**Artform Home Plans**  
AFHP Design # 408.015 KR  
© 2008-2014 Wendy Welton 603.431.9559

**Hopscotch w/Porch**  
8 Cushman Way, Greenland Commons, Greenland, NH

Issued for:  
Construction

**Column Detail**

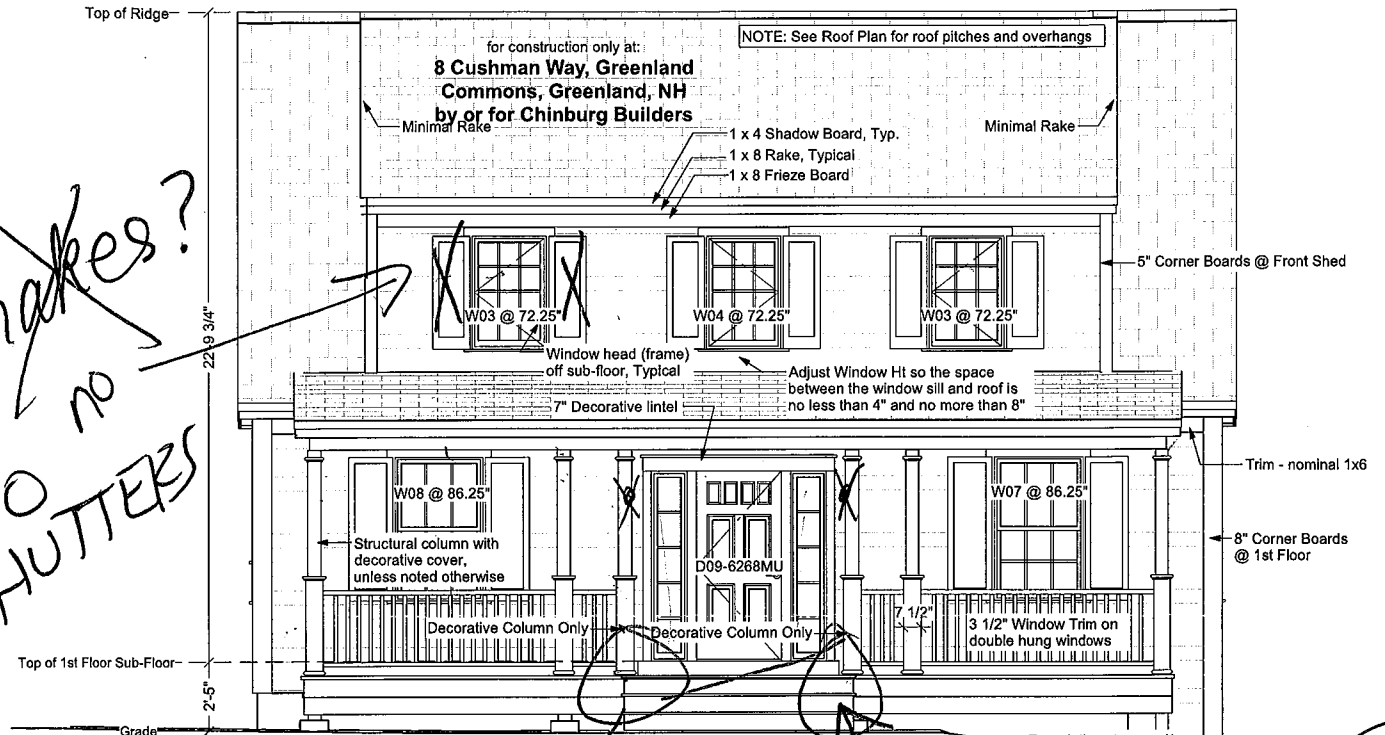
combine columns to create 2 bigger structural

**Front Elevation**

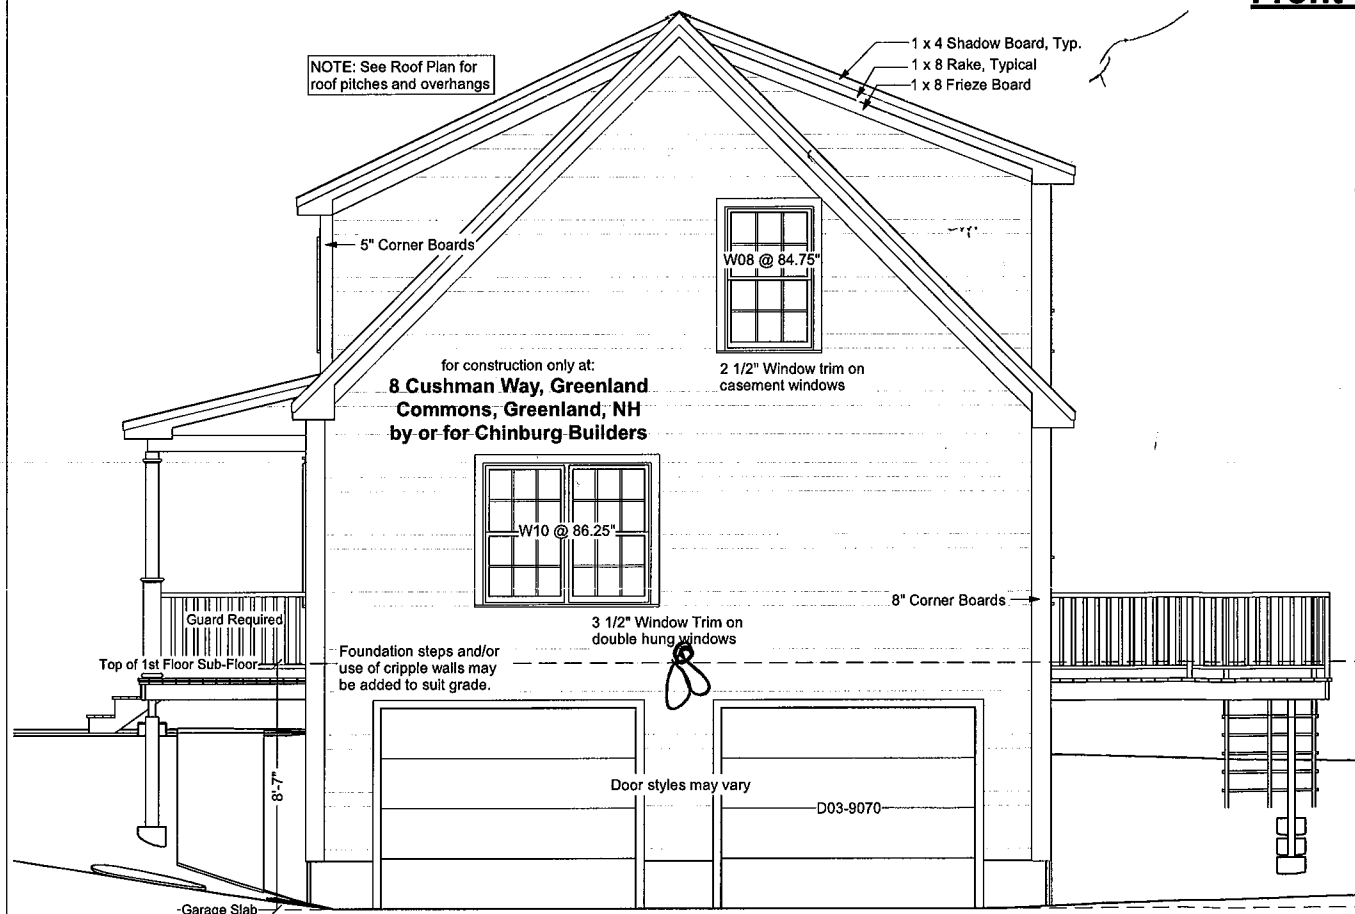
6/1  
Windows

~~Shakes?~~  
no  
SHUTTERS

Foundation Plan

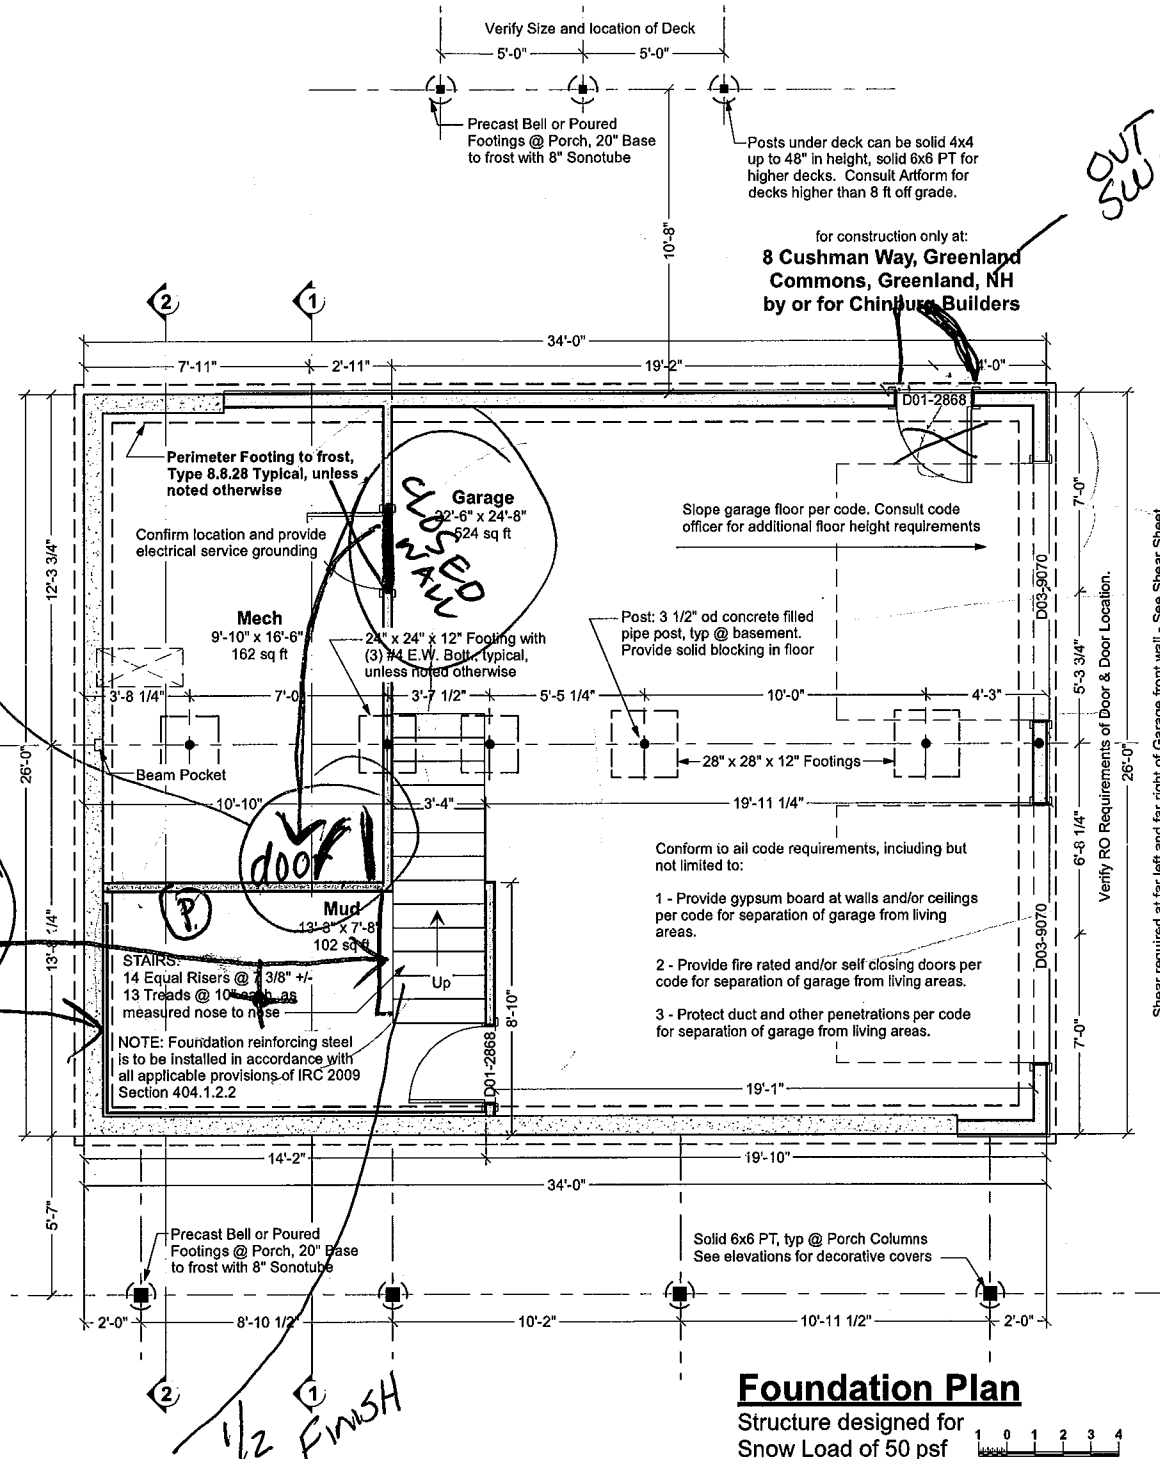
ceiling & walls  
duct for heat

NEW DOOR LOCATION
